10230 WILDLIFE RD

APPLICATION FOR IMPROVEMENT PERMIT FOR RESIDENTIAL SITE INDIVIDUAL WATER AND WASTEWATER SYSTEMS PROGRAM

IMPROVEMENT PERMIT for a RESIDENTIAL ON-SITE WASTEWATER TREATMENT & DISPOSAL SYSTEM

RE: **Request for revisions to the Improvement Permit for Lot 32** at The Sanctuary:
MCHD File #5688B

Sketch of Soil Evaluation Locations

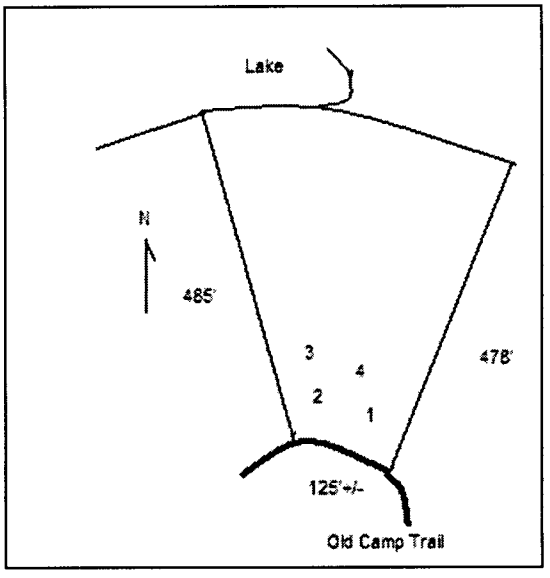
COMMENTS:
100% repair required

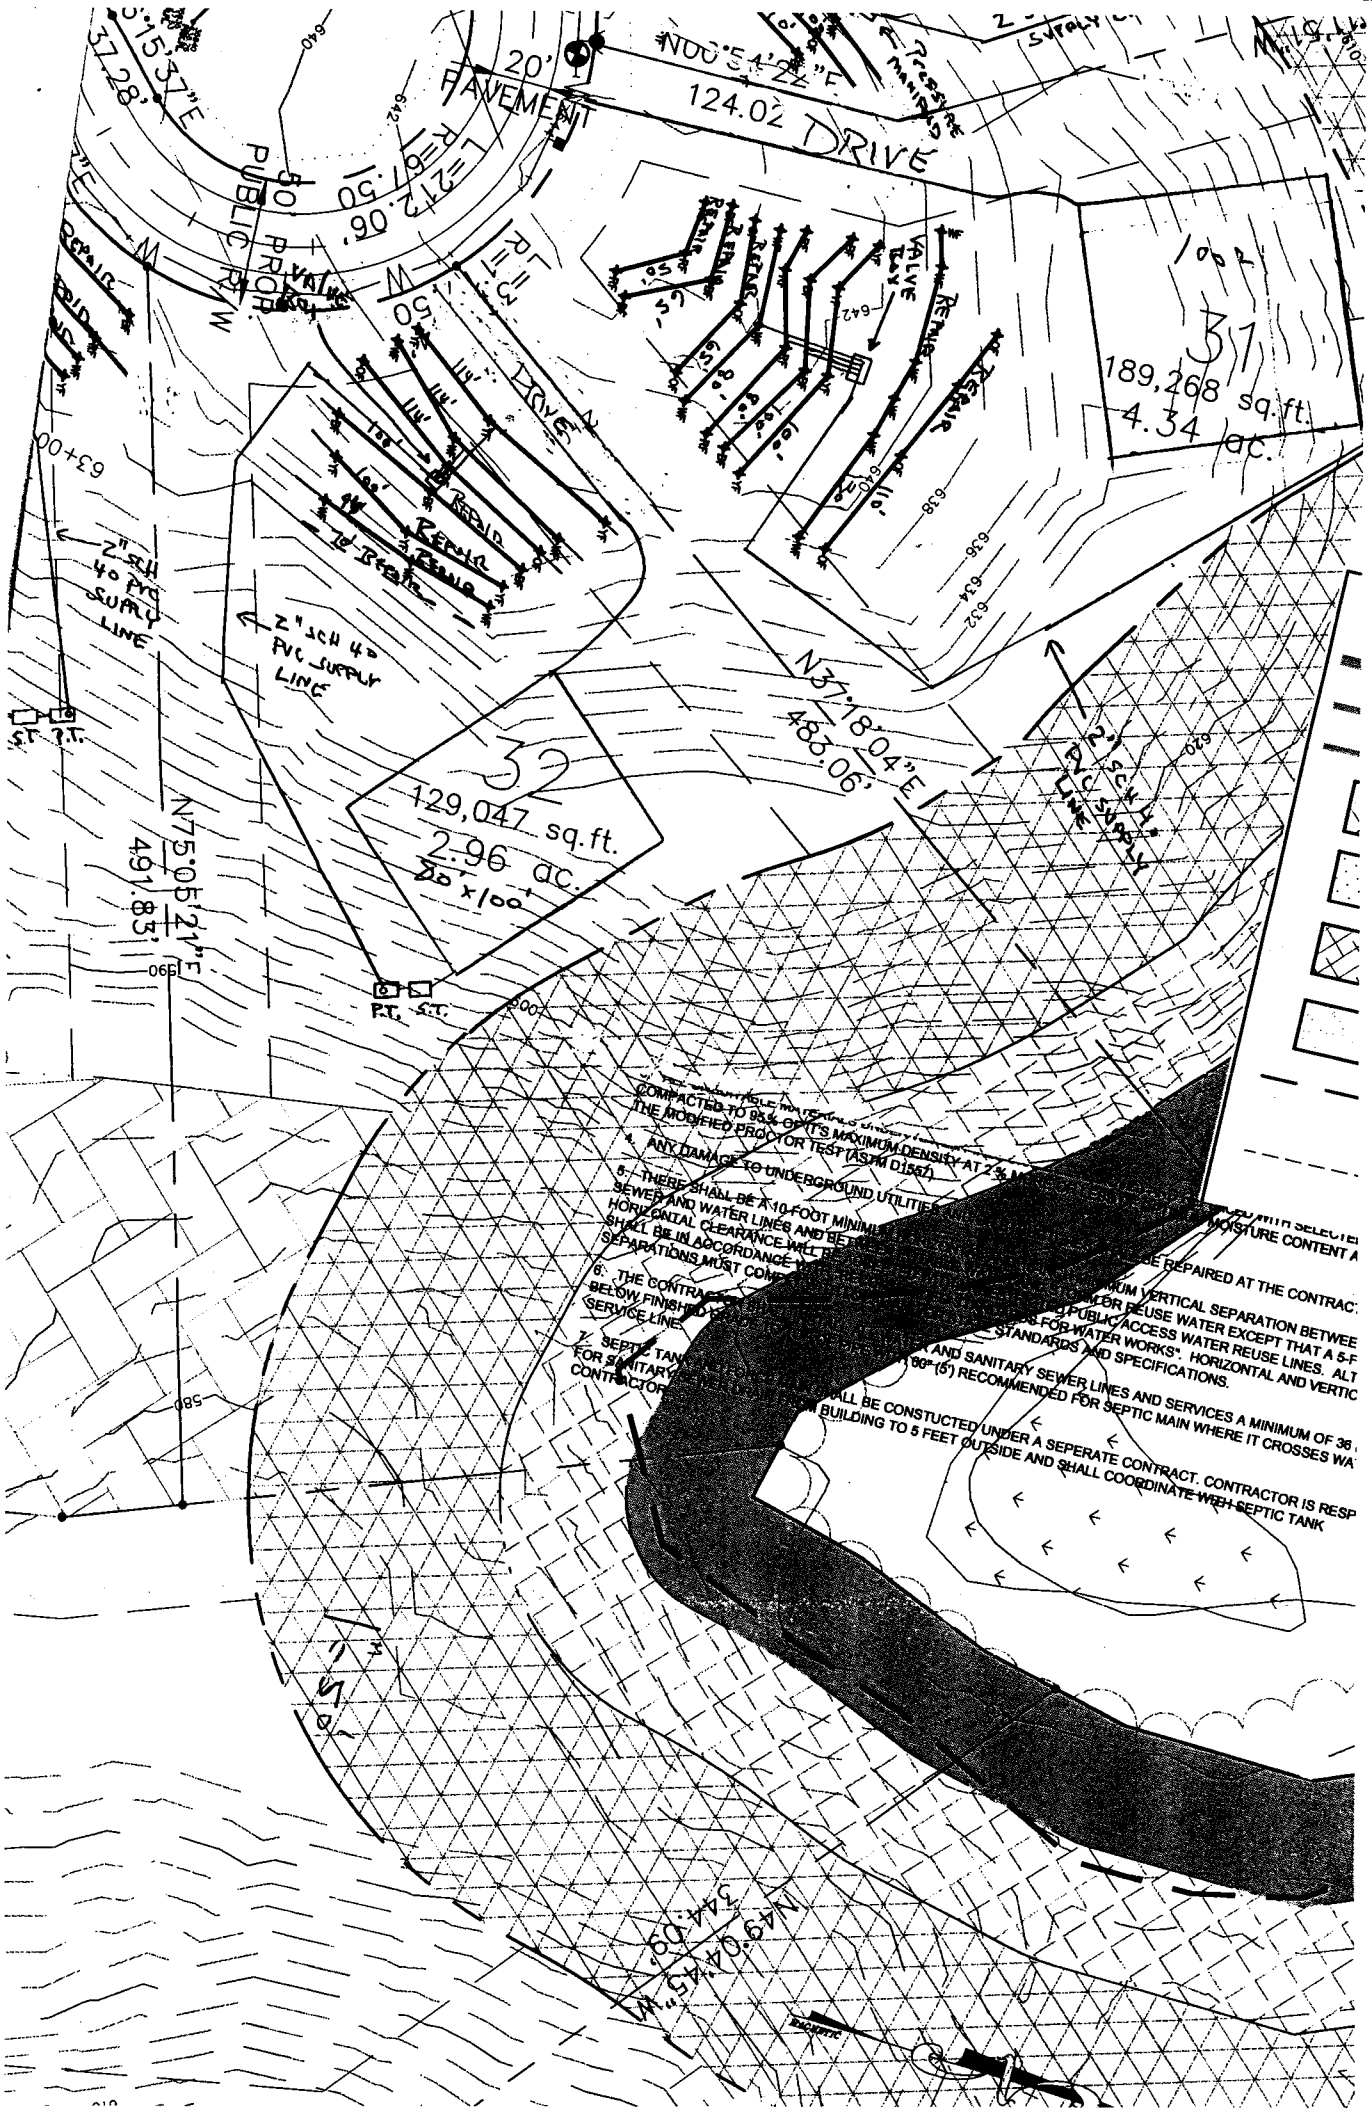
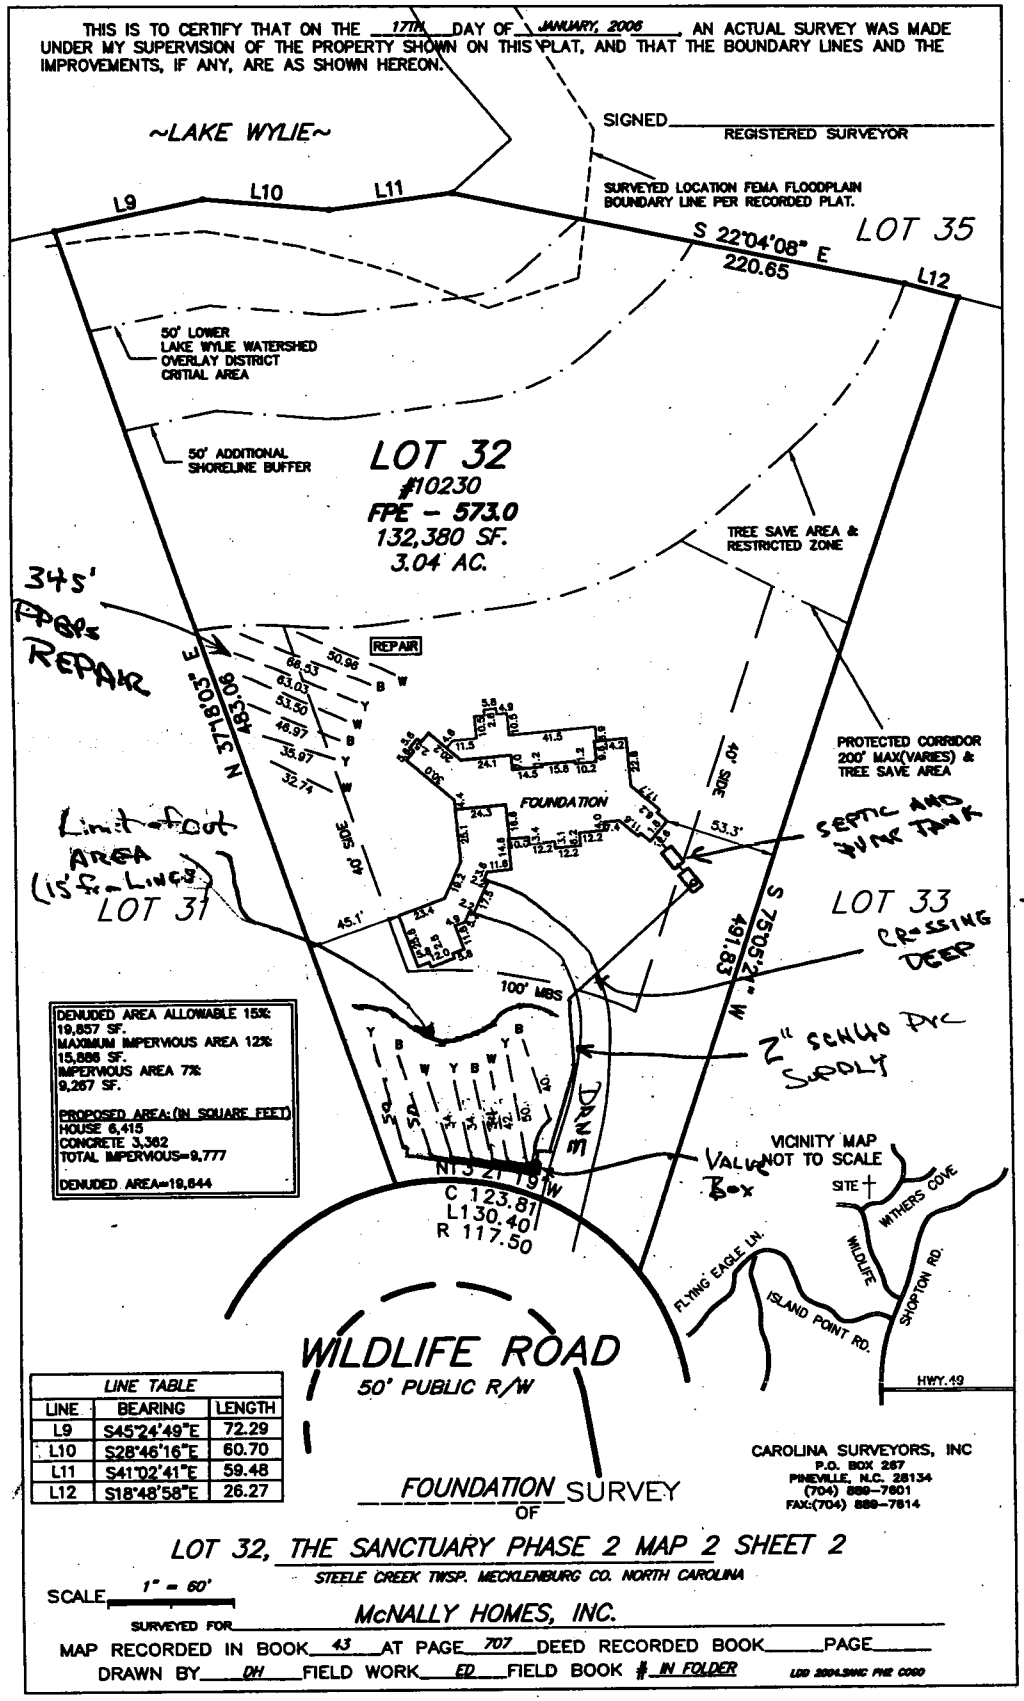
The Sanctuary at Lake Wylie is requesting a revision to the Improvement Permit for the above referenced lot. Mr. Bill Marlin has evaluated the soils (see attached MCHD soil sheets) and S&ME, Inc. has flagged the revised system and repair on the lot. The septic lines have been located by the surveyor and are shown on the attached maps provided by McNally Homes, Inc. The builder has graded the septic area originally approved by the MCHD so the original Improvement Permit citing a January 17, 2005 plan should no longer be valid.

Now that the proposed system has been revised we strongly recommend fencing the entire primary and repair areas from any grading or other potential damage. This includes any area within 15 feet of the proposed system and repair. Any further grading by the builder should be approved by the MCHD with strict supervision of the grading contractor. Any further damage to the septic area may make the lot unsuitable.

Lot 32 The Sanctuary Septic System Revision

Number of Bedrooms	5
Basement or Crawl	Basement
Design Flow (gpd)	600
LTAR (gpd/ft2)	0.3
Primary System Type	**LP PPBPS**
No. Lines	8 (See Table)
Total Linear Feet	334
Trench Width	3' min.
Trench Spacing	9' min.
Pump Required	Yes
Distribution Device	Gate Valve Box w/ LPP Distribution
Maintenance Agreement Required	Yes
Length and Diameter of Supply Pipe	160' of 2" SCH 40 PVC
Size of laterals	1 1/4" SCH 40 PVC
Flow Rate through the system	36 gpm
Elevation head	to be determined by installer
Pressure head	3.0'
Friction head	approx. 6'
20% Contingency	by installer
Total Head	by installer
Pump Requirements	by installer
Dosing Volume	259 gal -2.3 doses/day @ design flow*
Volume of water pumped per dose	Calculated to specific tank by measure or dealer engineering specifications (1 cubic ft. of water equals 7.48 gal.)
Pump Run per dose	approx. 7.2 min.
Check Valve	Yes
Siphon Break hole	No
Repair System	**LP PPBPS**
Total Linear Feet	345

Comments: System Classification & Type: IIIA, 50% REDUCTION, PANEL BLOCK. INSTALL SYSTEM ACCORDING TO PLANS ON FILE SUBMITTED BY STME 2/20/06.
*MAINTENANCE AGREEMENT W/ CERTIFIED OPERATOR REQ. B/F TO RELEASE.
